Service Letter No. 379

SUBJECT: Landing Gear Safety Switch Harness

MODELS AFFECTED: PA-24 and PA-24 "250" Comanches
Serial Numbers 24-1 to 24-3284 incl.

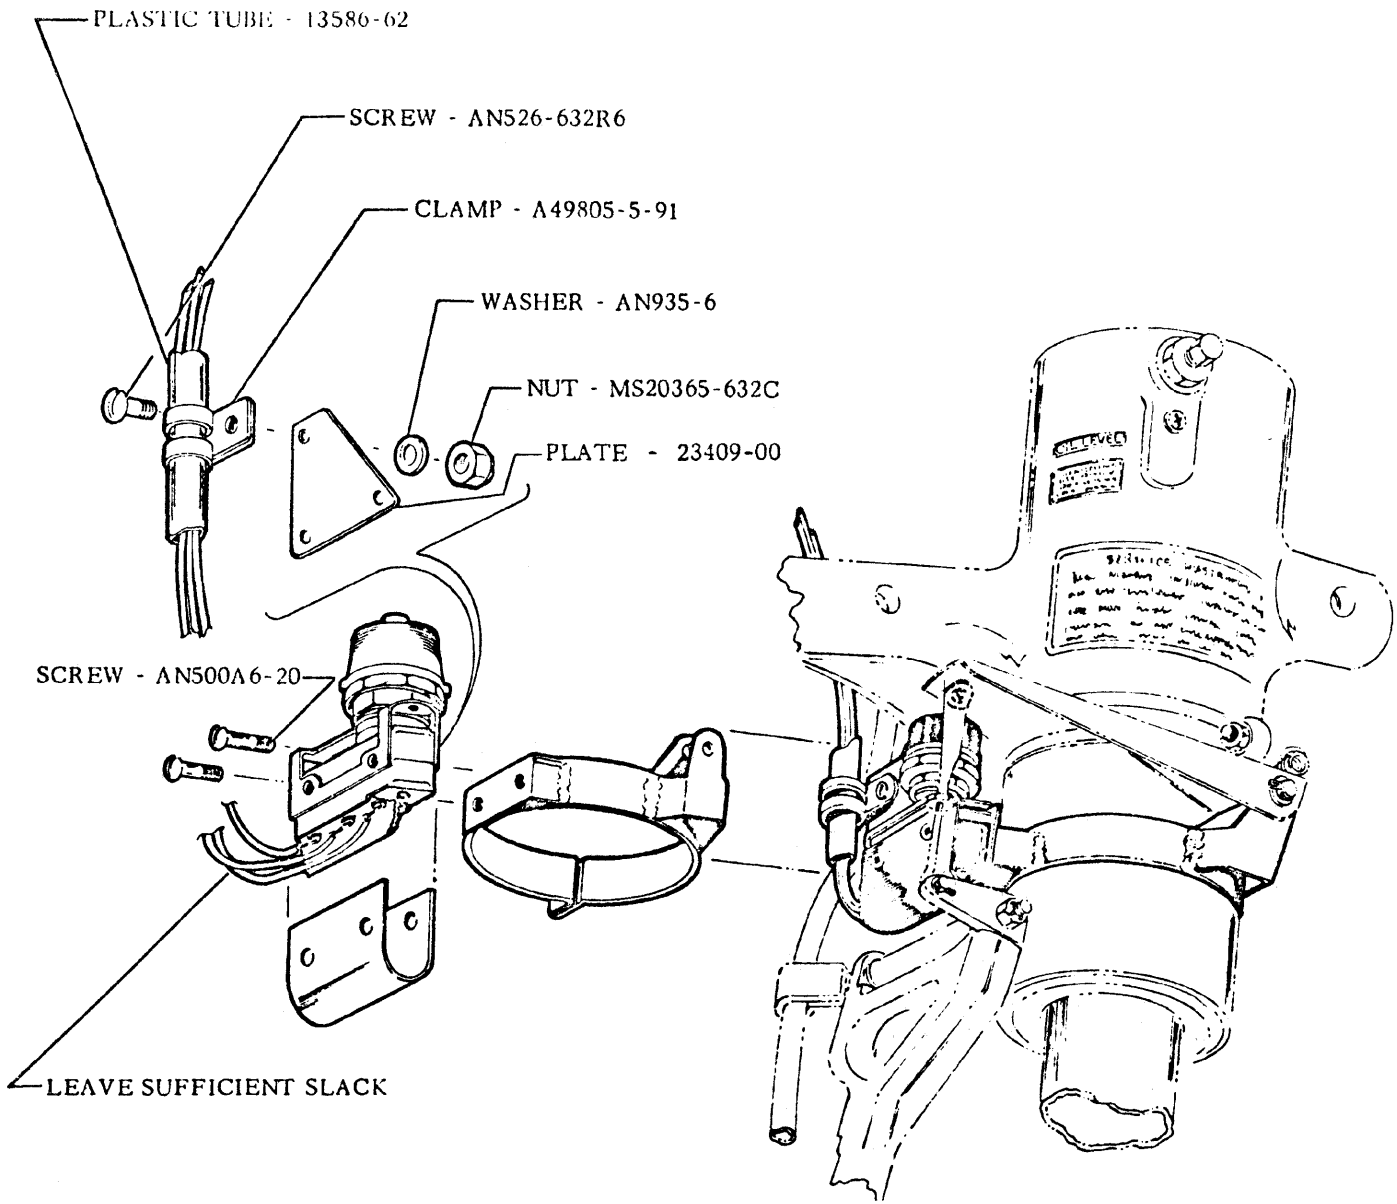
We have been advised that over extended periods of operation, there is a possibility of a wire or wires in the landing gear safety switch harness becoming broken at the switch. This condition would cause malfunction of the safety switch.

A kit, consisting of a bracket, clamp, plastic sleeve and necessary hardware, is available for use in the subject aircraft. It is recommended that this kit be installed in the referenced aircraft as it will support the wire harness of the safety switch. See sketch on the reverse side of this Service Letter.

Until such time as this kit is installed, an inspection of the safety switch and related wire harness should be performed at each 100 hours of operation to ascertain this condition does not exist.

The part number of this kit is 754 475, unit price \$1.08, and is available through your Piper distributor or dealer.
